Rosefield Solar Farm: consultation on a proposed change to a Development Consent Order application

Rosefield Solar Farm

TITLE:
 LOCATION OF PROPOSED CHANGE

PINS REFERENCE NUMBER:
 EN010158

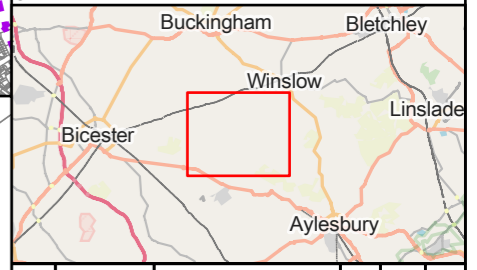
As a result, we are seeking to make a formal change to the Application to include a bridleway link (‘the Proposed Change’), which would be accessible to the public during the operation (including maintenance) phase of the Proposed Development.

Enclosed is a plan which shows the proposed location of the bridleway link, which is located entirely within the Order Limits. The bridleway link would connect the existing dead-end bridleway ECL/10/5 to the north of Field D27 to bridleway QUA/40/2 and QUA/40/3 which runs along the southern edge of Fields D28 and D29.

The total length of the bridleway link would be approximately 0.9 km long, and would follow the proposed internal access track through Field D27 and then PRow Footpath (reference ‘QUA/41/1’) through Field D28.
